TECHNICAL SERVICE BULLETIN

SUBJECT: **AUTOMATIC TRANSMISSION HYDRAULIC CIRCUIT — SERVICE MANUAL CORRECTION**

NO. TSB-91-23-006
DATE February, 1991
MODEL 1987-90 Van/Wagon, 1990 Montero

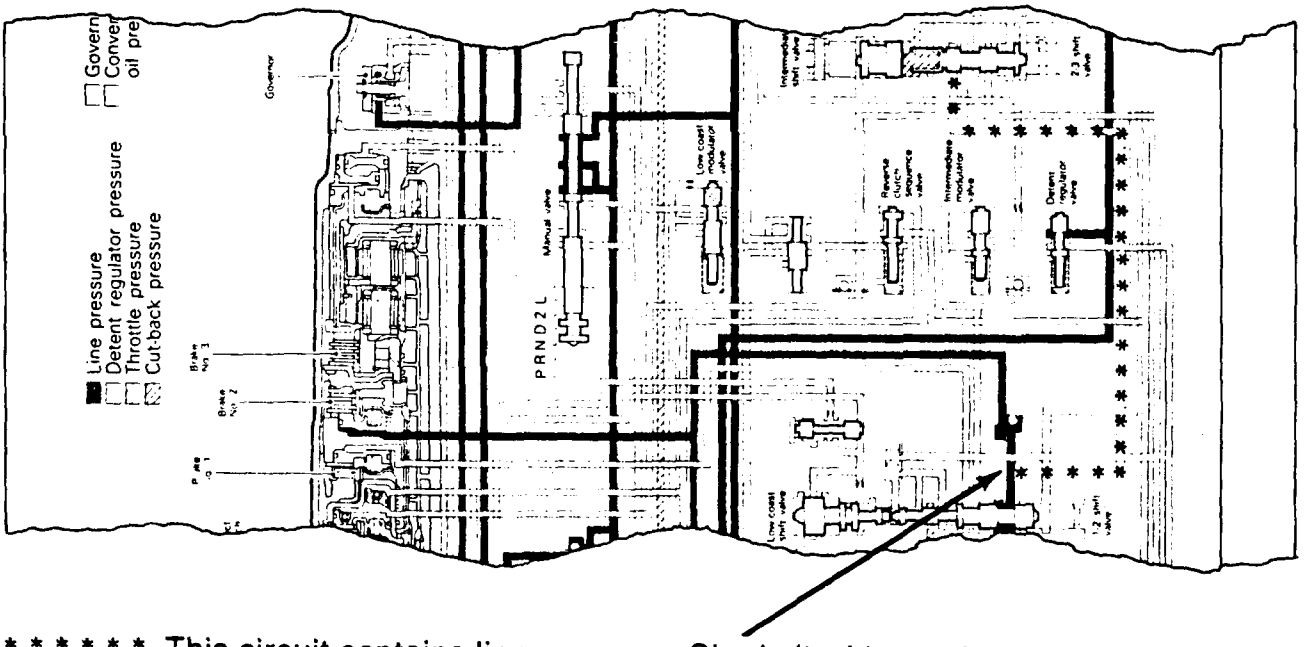
* * * * * * This circuit contains line pressure. Shade it with a red-colored pencil or pen to match the other line pressure circuits.
